5/25/10

NIBCO INC. FIELD NOTIFICATION

Photo A - "10" Date Code

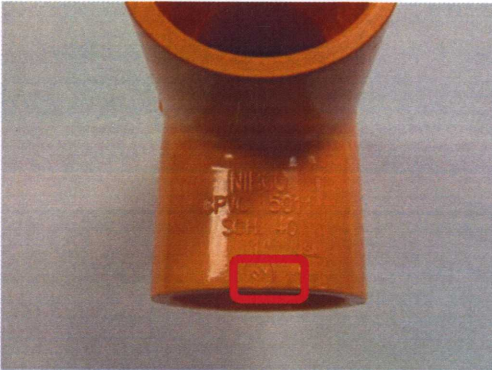
NIBCO INC. has identified a compatibility/fit issue with certain 1"x1"x1" V5011-010 SXSXS CPVC fire protection tees when installed in conjunction with the Potter[®] VSR-SG model flow switch. **DO NOT INSTALL** the Potter[®] flow switch in 1" CPVC tees produced between February 15, 2010 and May 18, 2010. NO reducer tees or threaded insert tees are included in this Notification, only the 1" x 1" x 1" SXSXS CPVC tee. The tees with compatibility issues can be identified in the following manner:

- The fitting is molded WITH a "10" date code molded into the tee on a round pin just below the 1" marking on the side of the outlet (as per Photo A) AND the NSF[®] pw logo molded on the opposite side of the outlet (as per Photo B).
- The date code on the box and bag of the tees are between February 12, 2010 (Julian Date Code 04310) and May 18, 2010 (Julian Date Code 13810) as per Photo C. All previous date codes are acceptable for use with the Potter[®] switch.

NIBCO has eliminated this compatibility/fit issue in current production. Revised compatible fittings can be identified by:

- The fitting is molded WITH a "10" date code molded into the tee on a round pin just below the 1" marking on the side of the outlet (as per Photo A) AND the NSF® pw-G logo molded on the opposite side of the of the outlet (as per Photo D). Any "09" date code tees are fully compatible with the Potter® switch.
- The date code on the box and bag of Tees are NOT between February 12, 2010 (04310) and May 18, 2010 (13810), as per Photo C.
